2010 Interim Design Standard  
24" SQUARE PRESTRESSED CONCRETE PILE

Interim Date: 07/01/10  
Sheet No.: 1 of 1  
Index No.: 20624

ALTERNATE STRAND PATTERNS

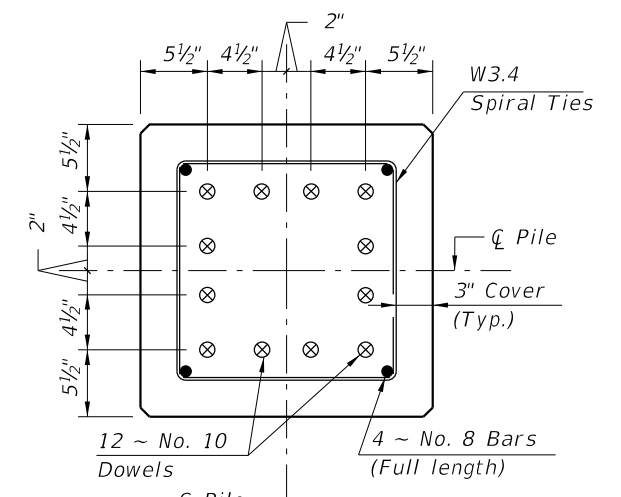
REVISIONS			
DATE	BY	DESCRIPTION	
07/01/10	GJM	"ALTERNATE STRAND PATTERNS" Deleted: "SR" strand pattern options.

- 16 ~ 0.6" Ø, Grade 270 LRS, at 44 kips
- 20 ~ 1/2" Ø (Spec), Grade 270 LRS, at 34 kips
- 24 ~ 1/2" Ø, Grade 270 LRS, at 31 kips

NOTE:  
Any of the given Alternate Strand Patterns may be utilized. The strands shall be located as follows:  
Place one strand at each corner and place the remaining strands equally spaced between the corner strands. The total strand pattern shall be concentric with the nominal concrete section of the pile.
